ASSESSMENT REPORT

Section 75W Modification Australian Bay Lobsters (DA 282-11-2004 MOD 2)

Figure 3: Sea water and wastewater truck routes, stages 1a and 1b

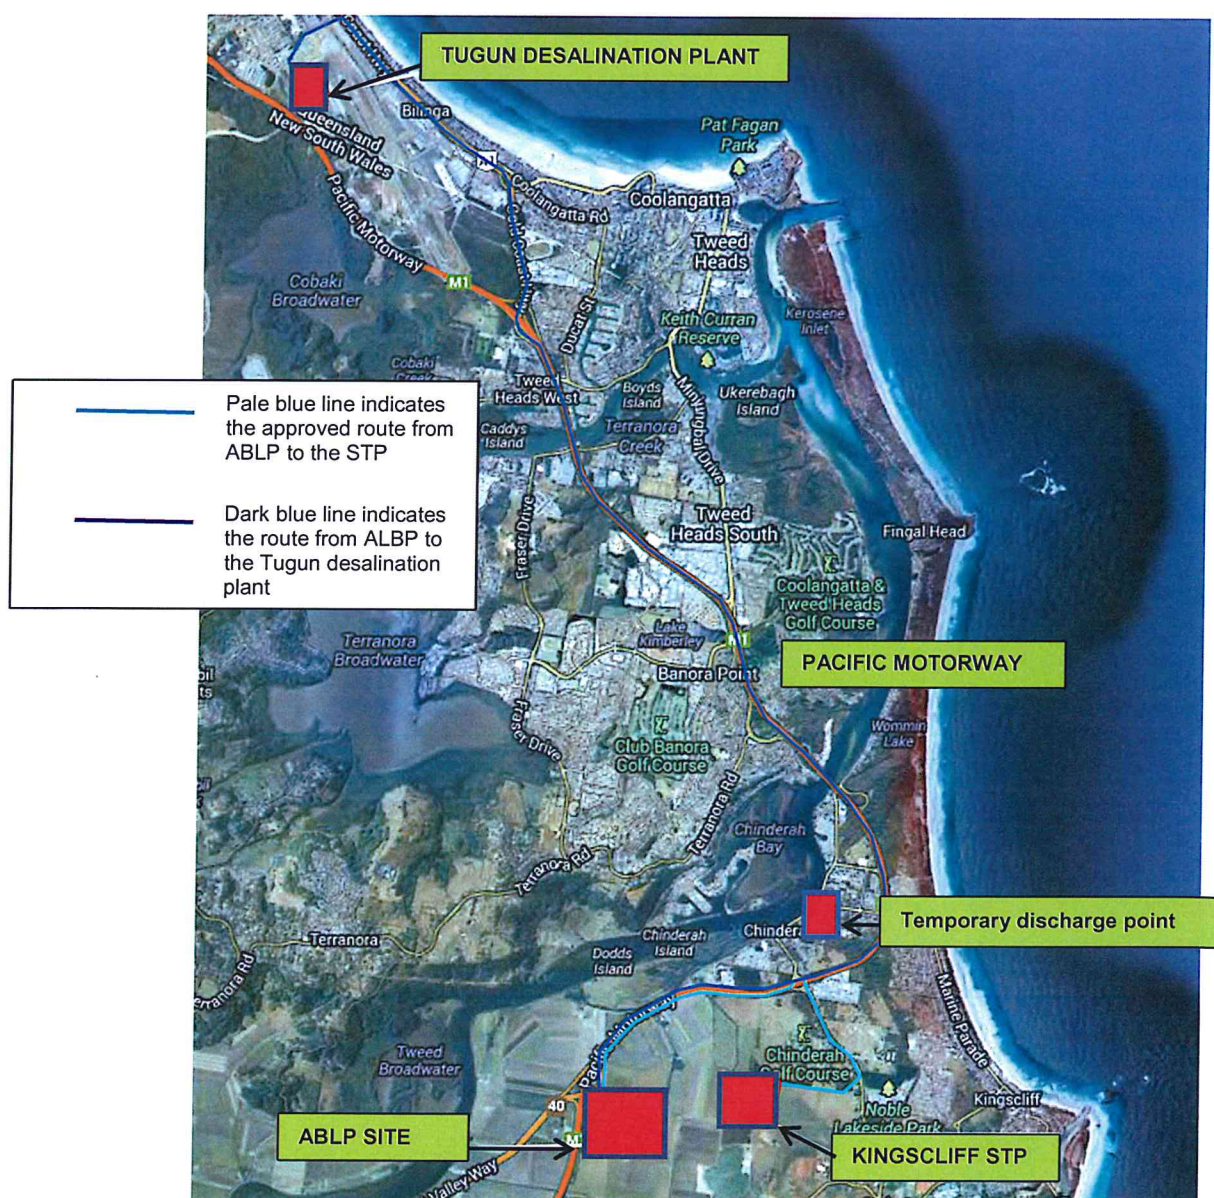
The amendments to the seawater supply and wastewater discharge arrangements are described in Table 1 below. The truck routes from the site to Tugun and the temporary wastewater discharge site at Chinderah are depicted in Figure 3.

Figure 4: Location of the temporary wastewater discharge in a drainage channel near the main channel of the Tweed River.

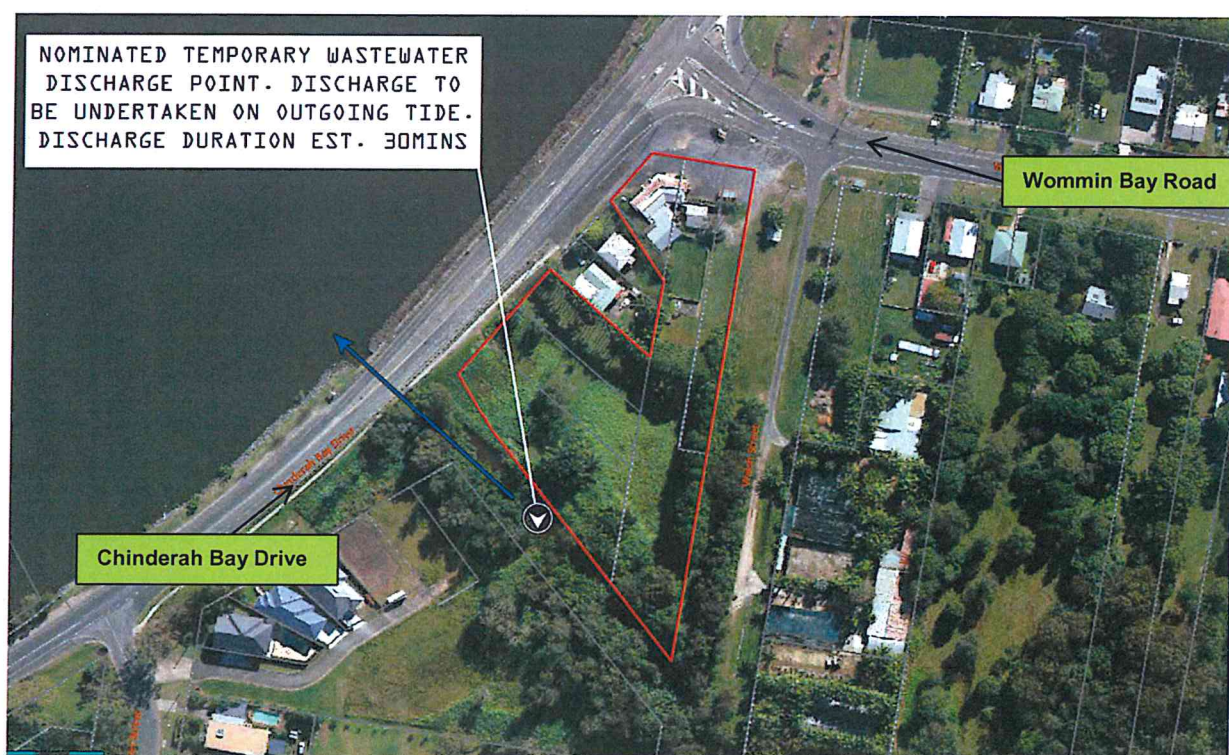
As discussed above, whilst the wastewater pipeline is being completed during Stage 1a, wastewater would be trucked from the ABLP site to a drainage channel of the Tweed River. The channel is accessed via private property at Wommin Bay Road, Chinderah, just south of the intersection of Chinderah Bay Drive (See Figures 3 and 4). Trucks would reach the channel via a gravel sealed access track from Wommin Bay Road.

The wastewater would meet the effluent discharge limits set out in the Kingscliff STP's Environment Protection Licence (EPL), and discharge from each tanker truck would take 30 minutes to release 20,000 litres (twice a day).

During the proposed Stage 1a, rather than being discharged directly to the STP via pipeline, ABLP is proposing to transport up to 40,000 litres of treated wastewater by tanker (two trips per day) to be pumped out directly to the nominated Tweed River discharge point (just south of the Chinderah Bay Drive and Wommin Bay Road intersection) as discussed in Section 2.

The EPA recommended that during Stage 1a, water quality sampling/testing should be undertaken twice weekly, both prior to loading into tanker and also at the point of discharge. These requirements (and concentration limits) would be included in the EPL for the site.

To further minimise potential water quality impacts at the temporary discharge site, the EPA and Council have recommended the following additional conditions:

- that discharge into the drainage channel should only occur on the outgoing tide (to ensure nutrients are quickly dispersed),
- discharge should be undertaken in a manner that would not mobilise sediments; and
- no riparian vegetation is permitted to be removed from the drainage reserve to allow truck access, as it is considered to have high ecological value.

The Department has included both the EPA and Council's recommendations in the draft conditions of approval, and is satisfied that the recommended conditions would impose measures to ensure that any temporary water quality impacts from Stage 1a are adequately managed and monitored, and discharge into the drainage channel would not impact on sediments or vegetation at the point of discharge.
